Form 3160-5
(June 2015)UNITED STATES
DEPARTMENT OF THE INTERIOR
BUREAU OF LAND MANAGEMENTFORM APPROVED
OMB No. 1004-0137
Expires: January 31, 2018**SUNDRY NOTICES AND REPORTS ON WELLS**
Do not use this form for proposals to drill or to re-enter an abandoned well. Use Form 3160-3 (APD) for such proposals.5. Lease Serial No. **NMNM-69642**

8. Well Name and No. **Cato San Andres Unit 204**9. API Well No. **30-005-20556**10. Field and Pool or Exploratory Area
San Andres

**Cato San Andres Unit 204
30-005-20556
BLM
June 5, 2023
Conditions of Approval**

PROPOSED			
Author:	Abby @ JMR	Well No.	#204
Well Name	Cato San Andres Unit	API #:	30-005-20556
Field/Pool	Cato; San Andres	Location:	Sec 7, T9S, R30E
County	Chaves		1980 FNL & 660 FEL
State	NM	GL:	4032'
Spud Date	11/25/1976

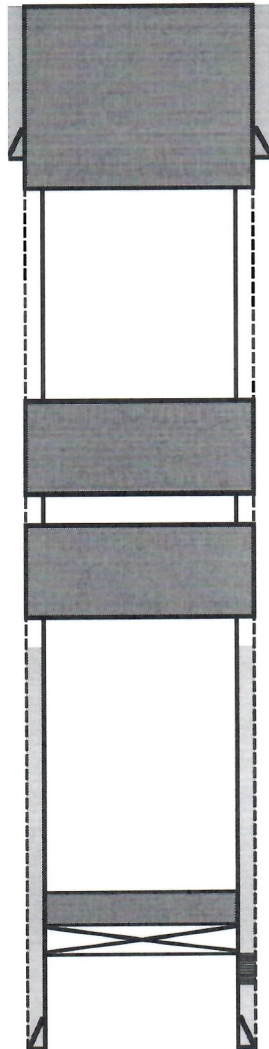
- 1. Operator shall place CIBP at 3,180' (50'-100' above top most perf) and place a minimum of 25 sx of Class C cement on top. WOC and TAG.**
- 2. Operator shall perf at 1,410' and squeeze Class C cement to 1,250' seal the Yates and bottom of the Salt Formation. WOC and TAG.**
- 3. Operator shall perf at 1,020' and squeeze Class C cement to 870' seal the top of the Salt Formation. WOC and TAG.**
- 4. Operator shall perf at 354' and squeeze class c cement to surface to seal the 8-5/8" casing shoe.**
- 5. Dry hole marker must be below ground.**
- 6. Surface reclamation will need to be completed once the well bore has been plugged. Please contact rflores@blm.gov for additional information.**
- 7. See Attached for general plugging stipulations.**

Plug #4: Perf & Sqz 166 sx class C cmt @ 354' & circulate to surface.
(138 sx outside, 28 sx inside)

Plug #3: Perf & Sqz 67 sx class C cmt w/ CaCl @ 1,020-870'. WOC & Tag (T/Salt)
(53 sx outside, 14 sx inside)

Plug #2: Perf & Sqz 71 sx class C cmt w/ CaCl @ 1,410-1,250'. WOC & Tag (Yates & B/Salt)
(56 sx outside, 15 sx inside)

Plug #1: Set 4 1/2" CIBP @ 3,180'. Spot 25 sx class C cmt w/ CaCl @ 3,180-2,862'. WOC & Tag.
